PRELIMINARY OVERALL DEVELOPMENT PLAN

WETMORE BUSINESS PARK OFFICE-SERVICE CENTER DEVELOPMENT

INFORMATION SHEET FOR
PRELIMINARY OVERALL AREA DEVELOPMENT PLAN
(P.O.A.D.P.)

Wetmore Business Park ☐ Preliminary Plan
Re: Office Service Center ☒ P.O.A.D.P.

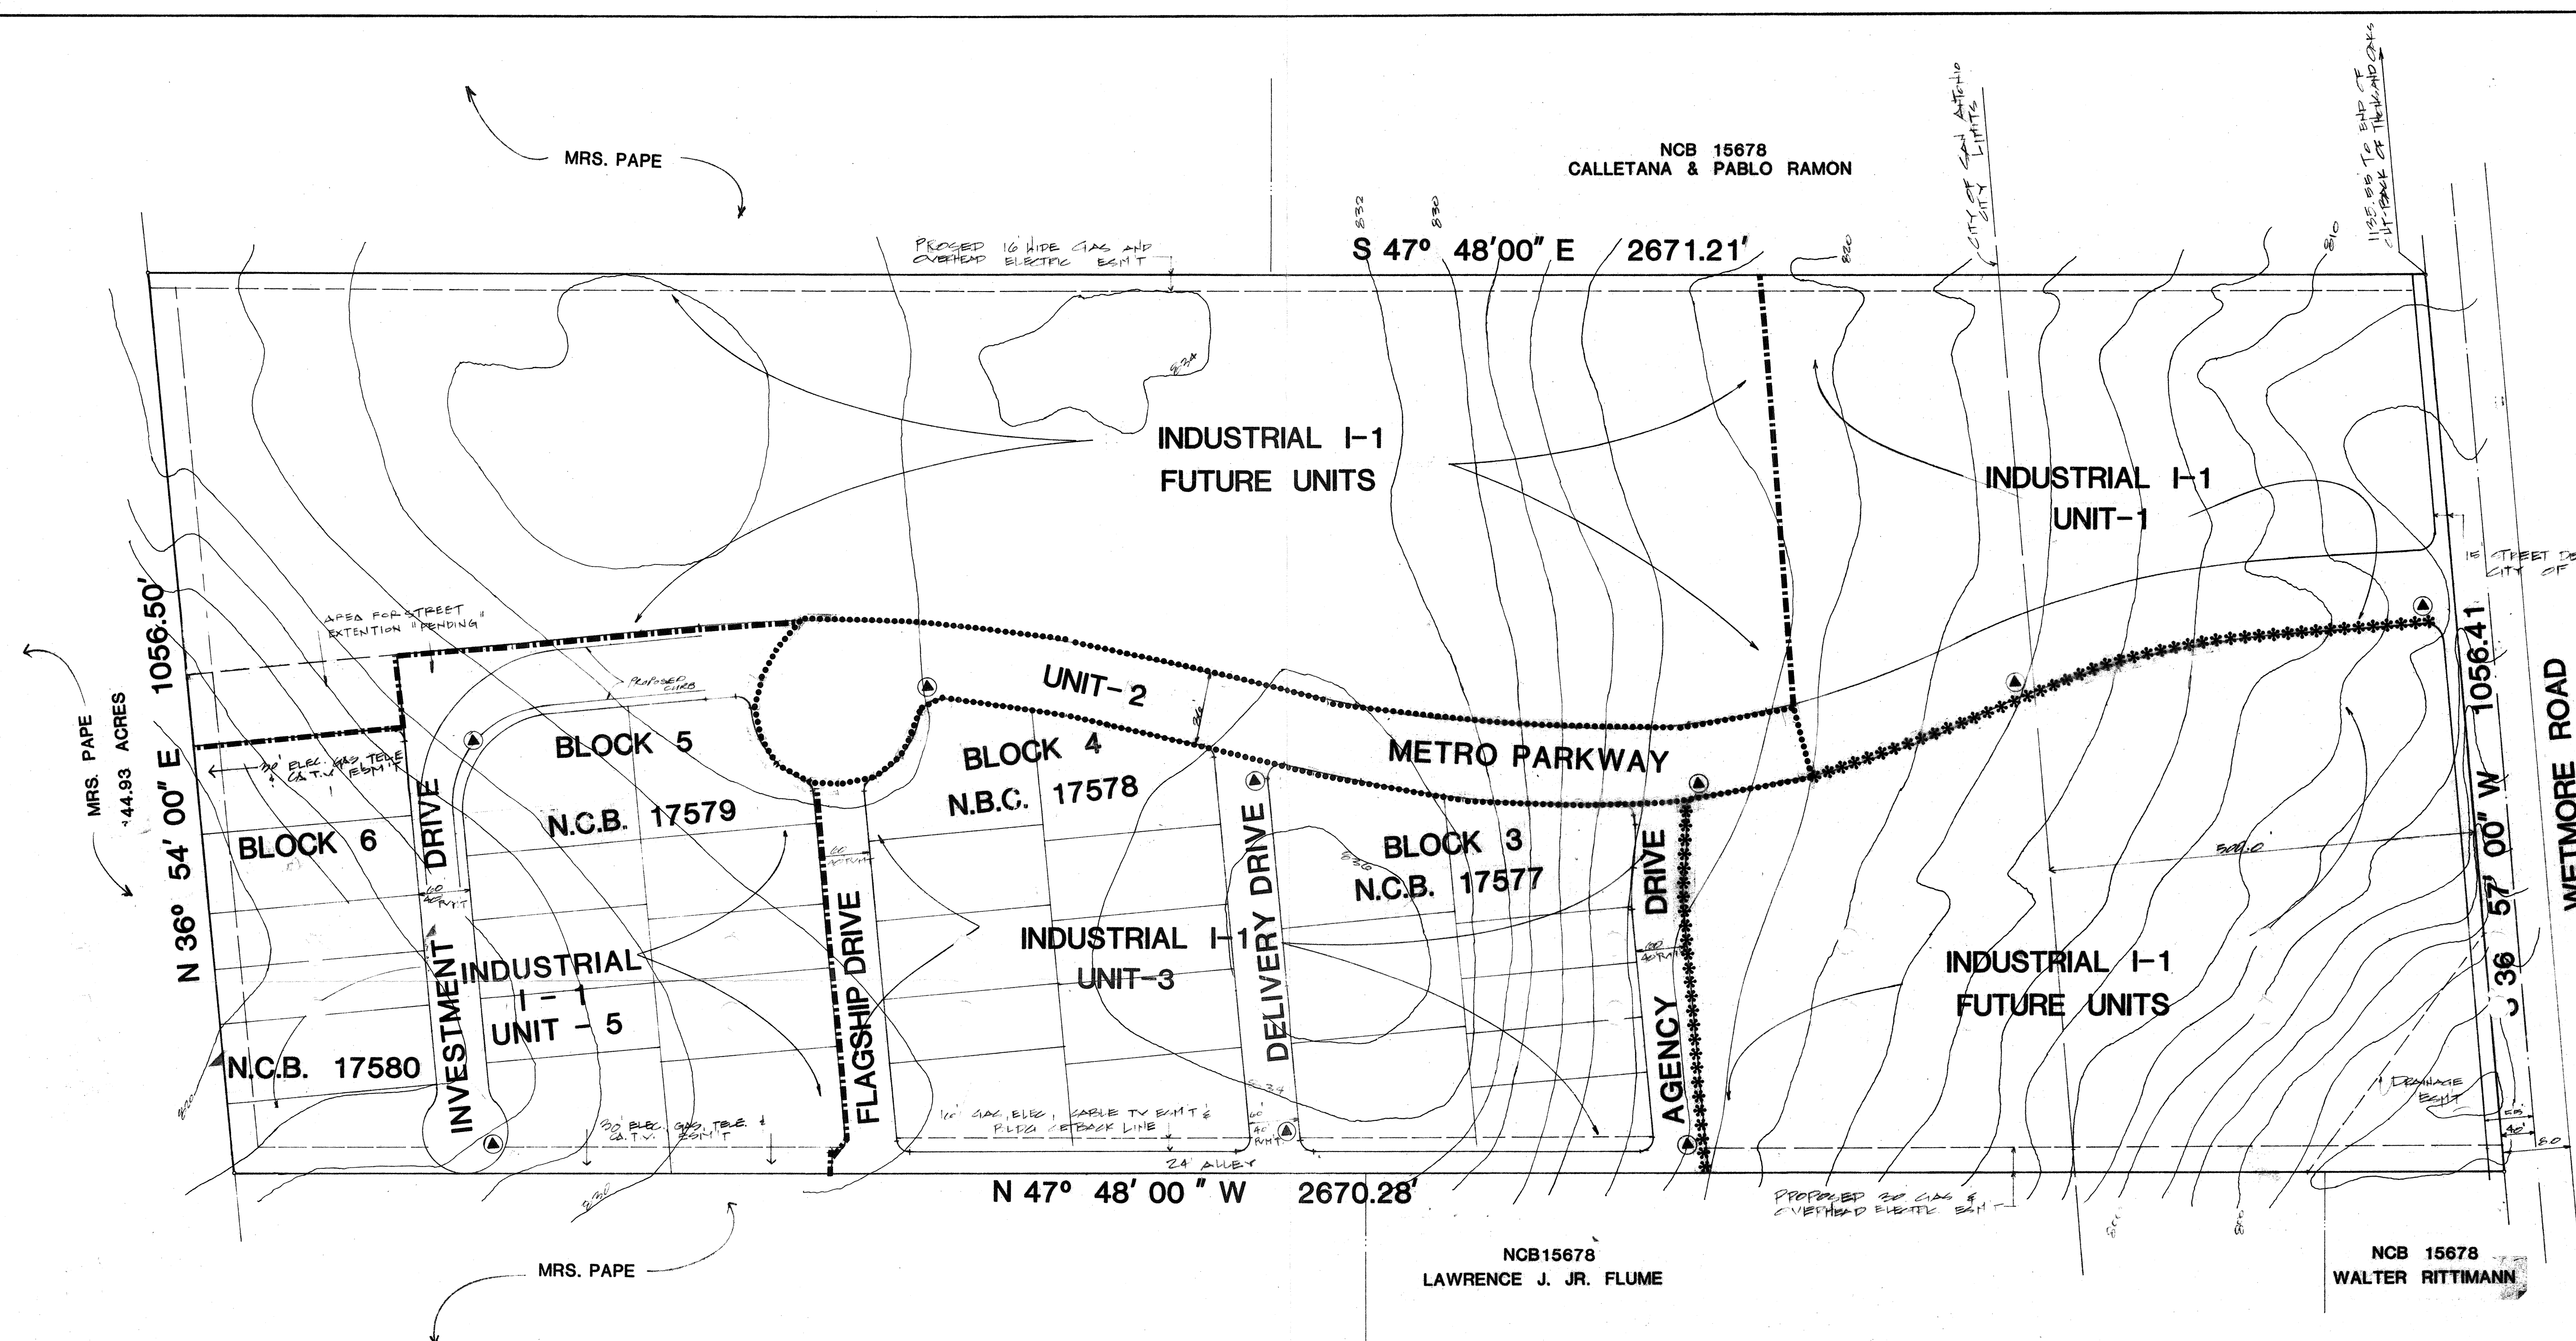
*CUL De Sac
length
1900'*

Revised to reflect ownership in the immediate area

New Proposal reflects extension of 86' facility to western boundary with temp cul de sac.

PRELIMINARY OVERALL DEVELOPMENT PLAN

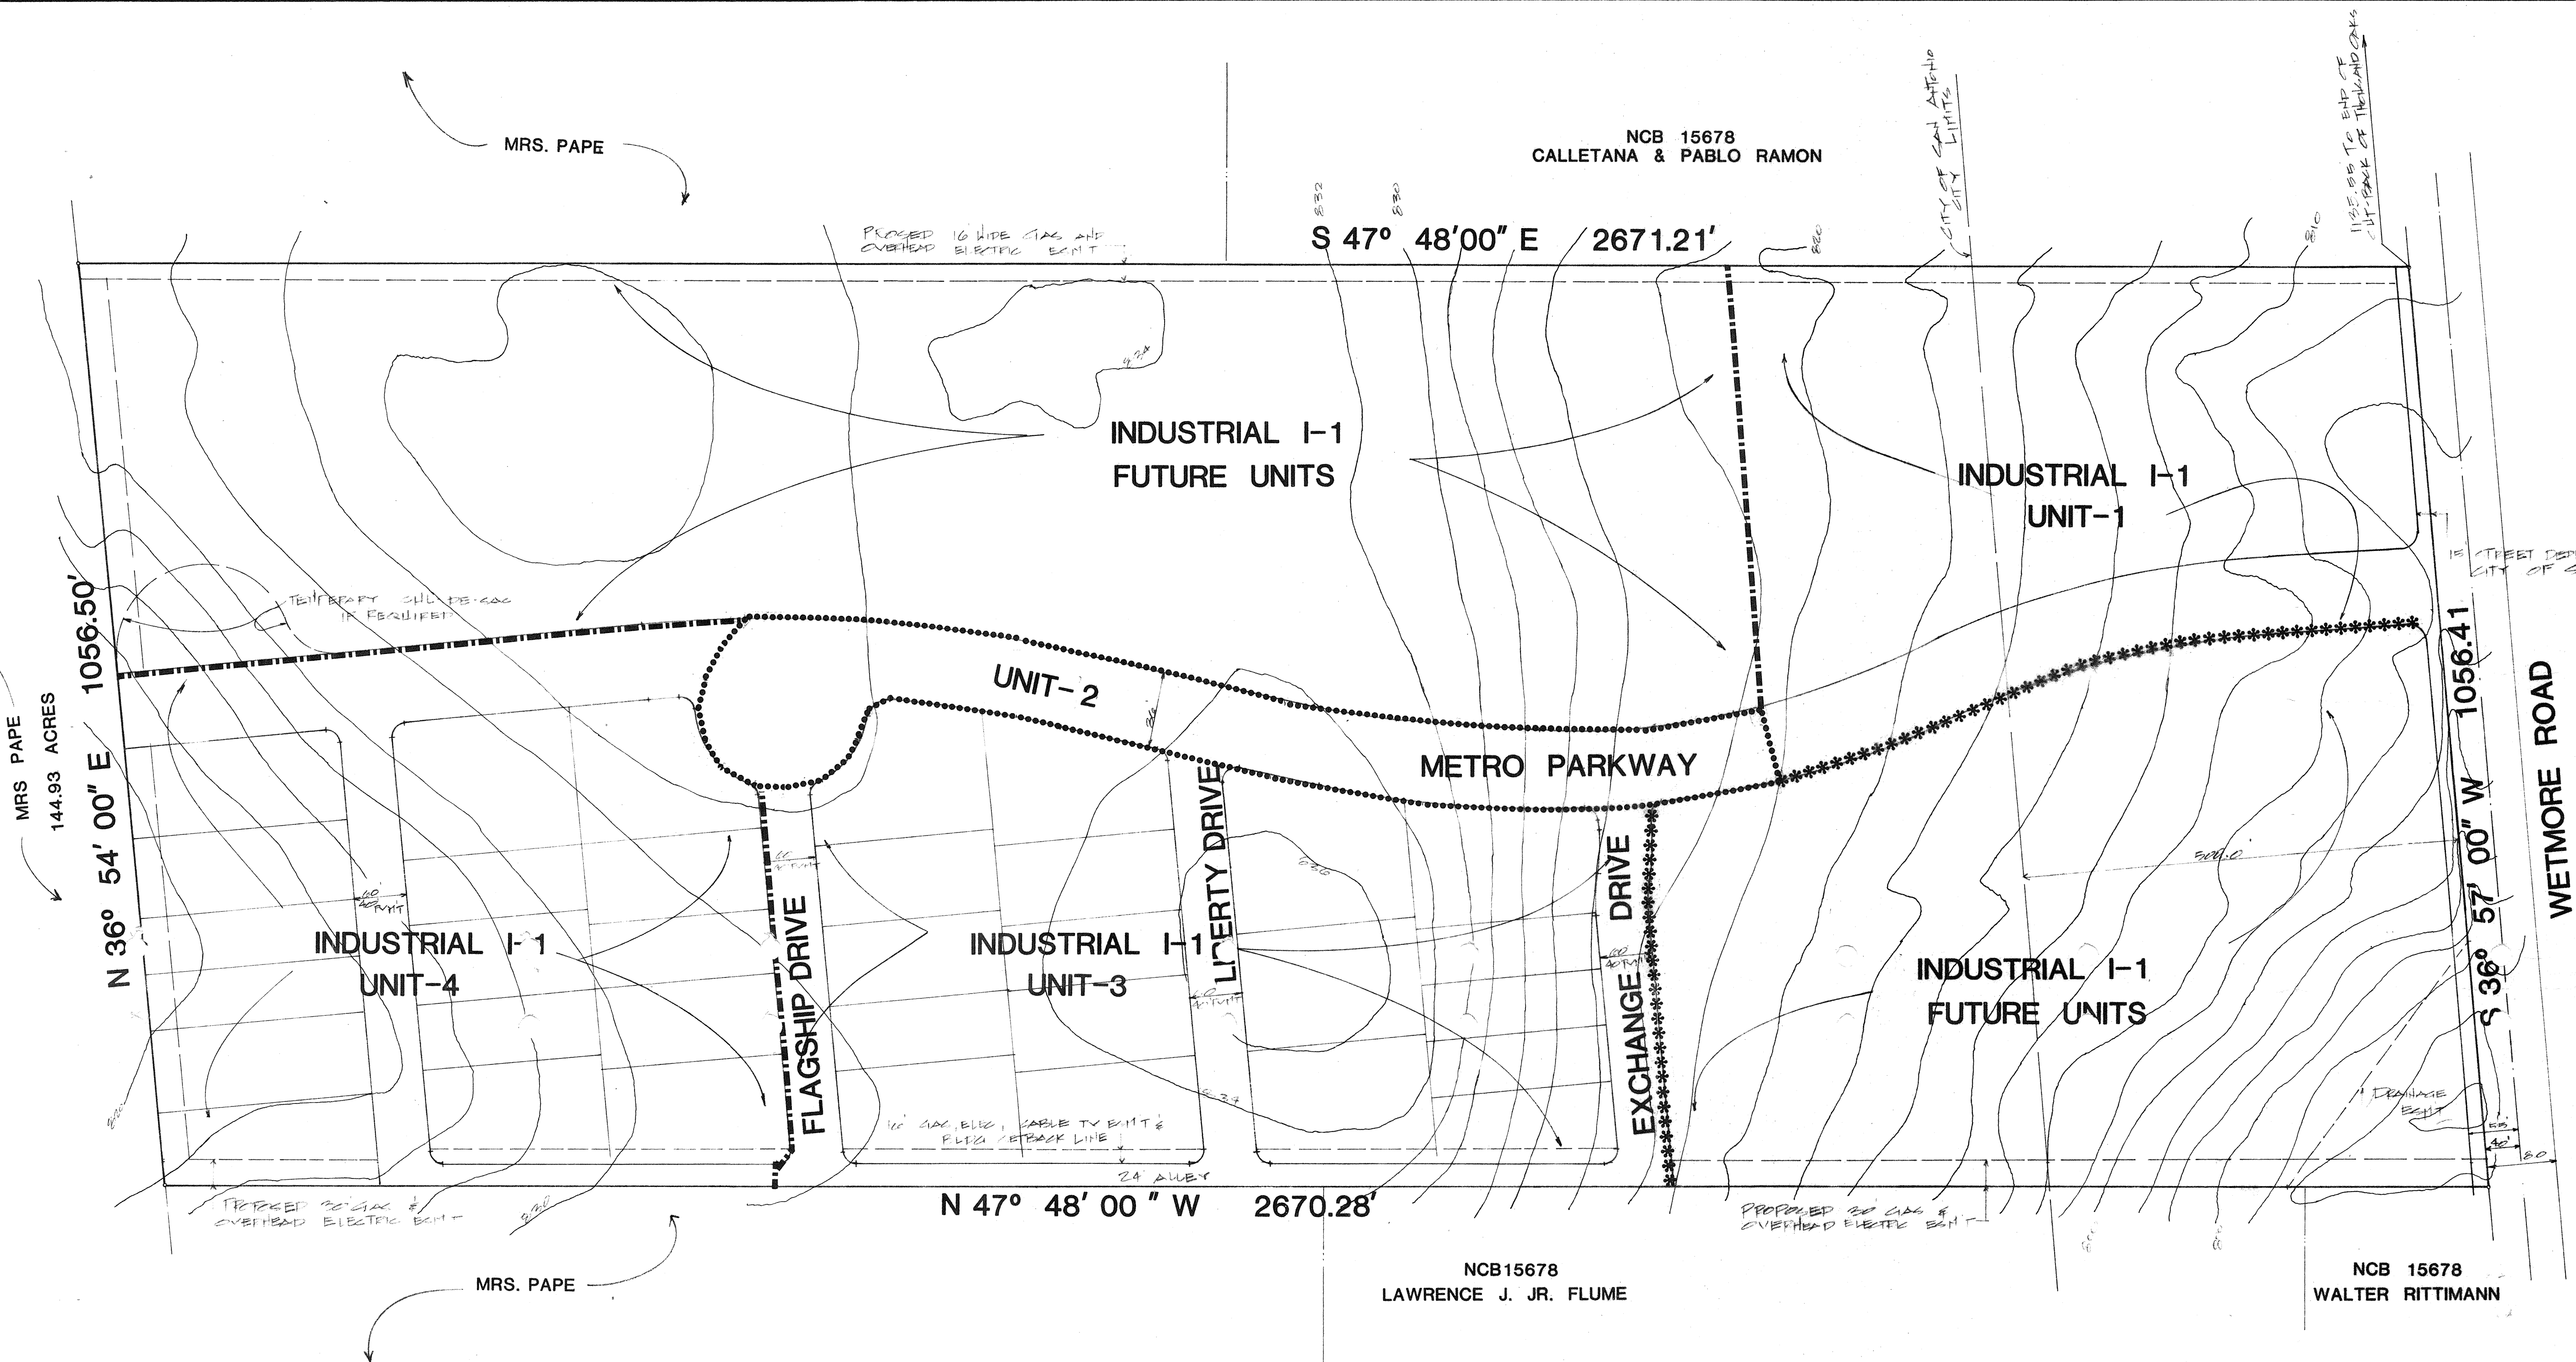
- ☐ Low density lots fronting onto major thoroughfares
- ☐ 24' alley(s)
- ☒ 36-10 ft Cul-de-sac for industrial development requires 100' centerline radius.

☒ Comments: The cul-de-sac at the end of Investment Drive requires 100' centerline radius.
